AUTO FLIGHT - REWORK OF GSE 164 - WIRING MODIFICATION

DATE: 18/Dec/2008 GSE-SB No.: GB190-22-0002

FIGURE 1: GSE 164 – WIRING MODIFICATION (SHEET 01 OF 03)

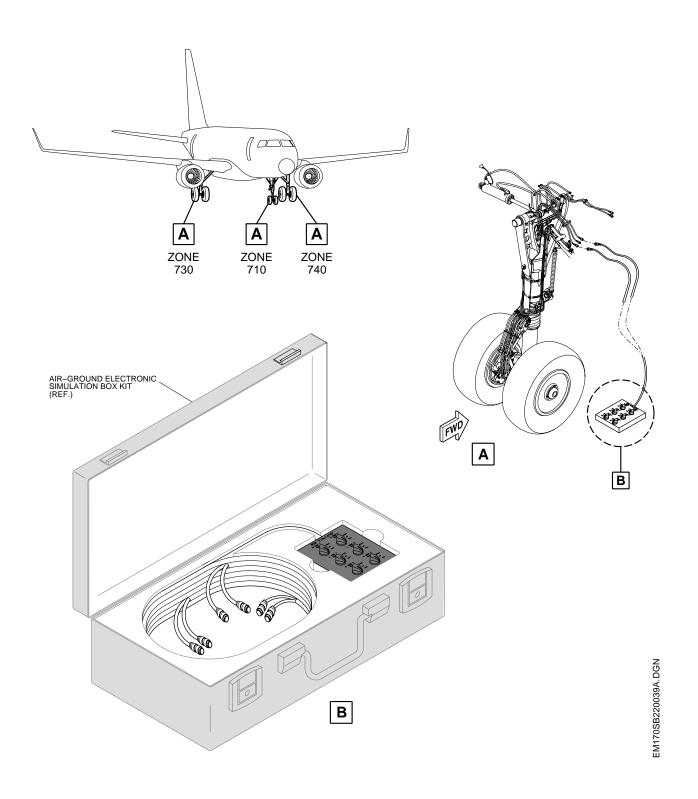
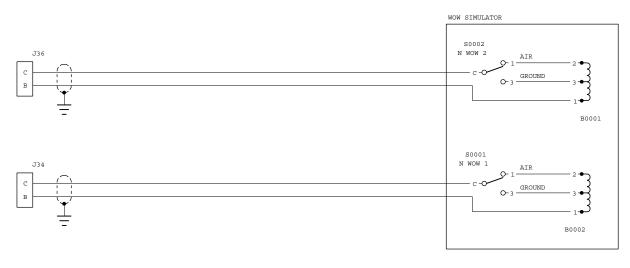
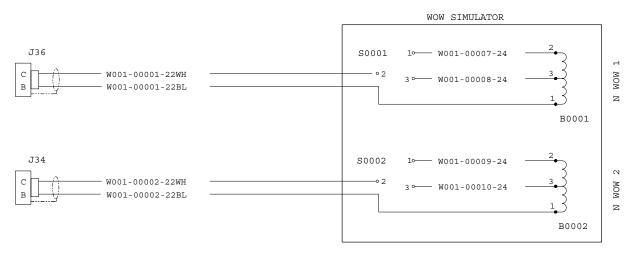
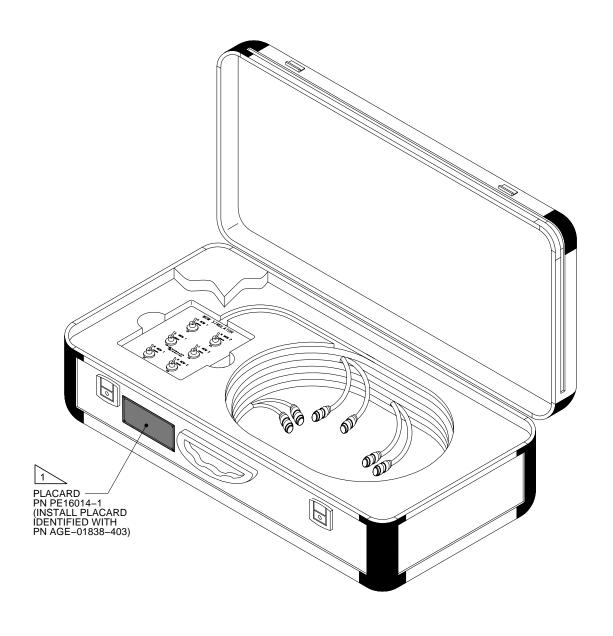
After analysis, Embraer GSE Engineering concluded that it is necessary to change the electrical installation presented in AGE-01837-401 by inverting the applicable wires.

The modification presented in this bulletin consists in inverting the electrical connections between two wires presented in AGE-01837-401 and reidentify the AGE.

- A. Make sure that GSE 164 is safe for maintenance.
- B. Make the electrical modification according to Figure 1.
- C. Replace placard with PN AGE-01837-401 with new PN AGE-01837-403, to reidentify the ground support equipment box. See Figure 2.
- D. Do the applicable test to GSE 164. Refer to CMM Component Maintenance Manual Chapter 32-62-00 Kit Simulation Air/ Ground Electronic Box.
- E. Restore the GSE to the normal operating condition.
- F. Enter the accomplishment of this bulletin in the applicable documents.
